CUMNOR PARISH COUNCIL

BOTLEY WEST SOLAR FARM (BWSF) REF: EN010147

1. Cumnor Parish Council's Assessment of the Applicant's 25 late submissions

Image 1

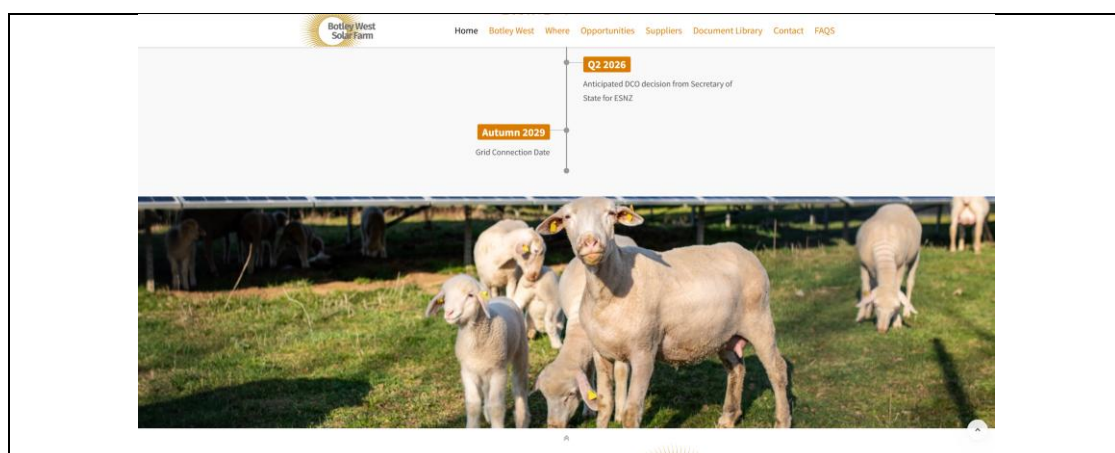
Simultaneously, the Applicant is asking the SoS to believe the grid connection date '*is expected to be amended to 2029 as this is the construction programme NGET are working to*' (**REP7-039**), members of the public are being informed by the Applicant's website that grid connection will occur in Autumn 2029 (image 2 below)

and at Cumnor Parish Council's August 3rd meeting, the CEO of PVDP stated that (CPC minute 203/26) NGET would *"connect us in 2030 with a one year fallback"*

So, the question remains unanswered. What is the proposed grid connection date?
